Staff Report

To: Salt Lake City Planning Commission
 From: John Anderson, 801-535-7214, john.anderson@slcgov.com
 Date: December 13, 2017
 Re: PLNSUB2017-00789 The Edith Planned Development

Planned Development

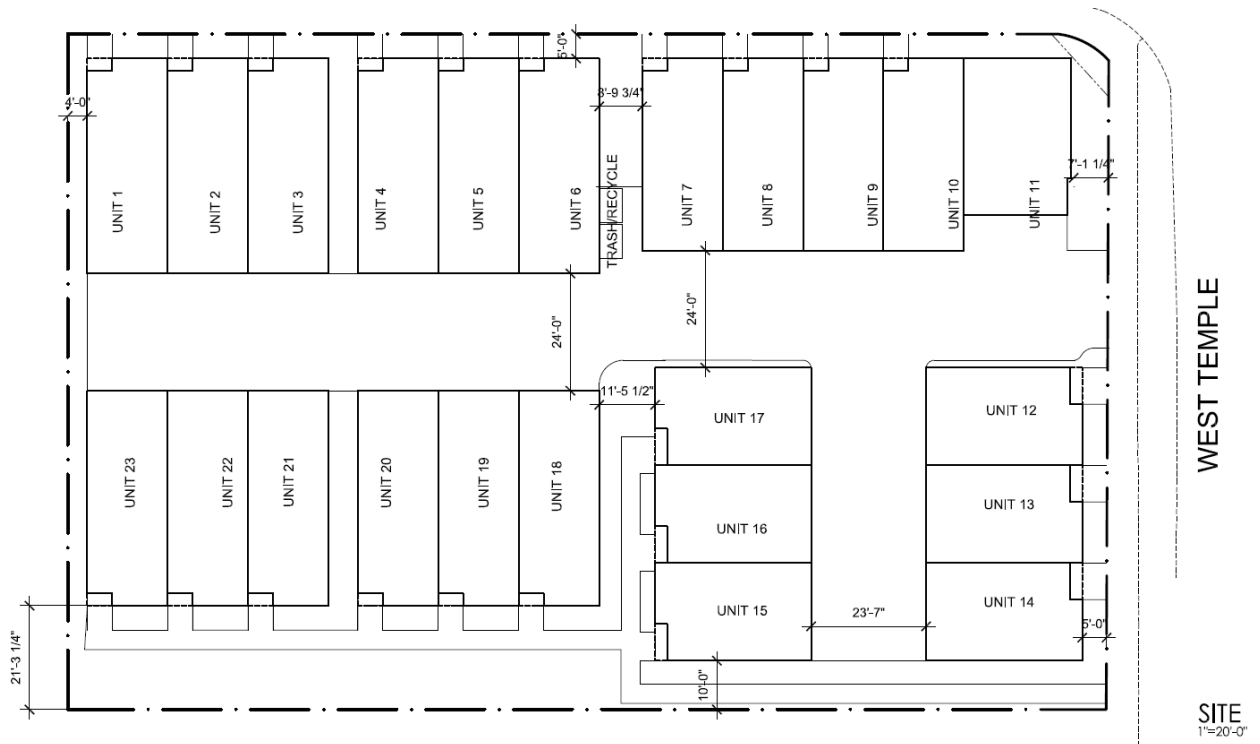
The image above shows the site plan for the proposed project. The properties along the south property line protrude into the rear yard setback.

The structures on West Temple face the public street and are partially located in the required rear yard setback. Because the structure faces the street and because it is a single-family attached unit rather than an apartment building, it interacts with the single-family dwelling to the south much like a side yard setback rather than a rear yard setback.

The property located to the south of the subject property is located in the R-1/5,000 (Single Family Residential District). The Zoning Ordinance requires a 10 foot landscaped buffer between the two zoning districts because the R-MU-45 Zoning District allows for more intense uses such as multi-family residential and limited commercial uses. The proposed development has included that landscaped buffer which requires a solid fence and increased plantings. In this case, the applicant is proposing a structure that is not out of scale with the neighborhood and is of a similar use. If this were not the case the reduction in the setback in that area may be inappropriate.
